RS-03-209

U. S. Nuclear Regulatory Commission  
ATTN: Document Control Desk  
Washington, DC 20555-0001Dresden Nuclear Power Station, Units 2 and 3  
Facility Operating License Nos. DPR-19 and DPR-25  
NRC Docket Nos. 50-237 and 50-249LaSalle County Station, Units 1 and 2  
Facility Operating License Nos. NPF-11 and NPF-18  
NRC Docket Nos. 50-373 and 50-374Quad Cities Nuclear Power Station, Units 1 and 2  
Facility Operating License Nos. DPR-29 and DPR-30  
NRC Docket Nos. 50-254 and 50-265

Subject: Request for Amendment to Technical Specifications to Add Requirement to Modify  
Linear Heat Generation Rate Limit During Single Recirculation Loop Operation

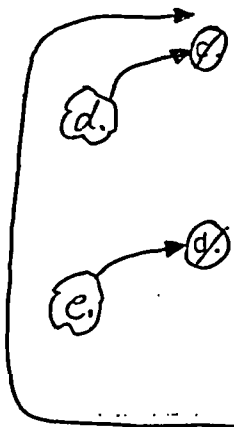
*C. LCO 3.2.3, "LINEAR HEAT GENERATION RATE (LHGR)," Single loop operation limits specified in the COLR;*
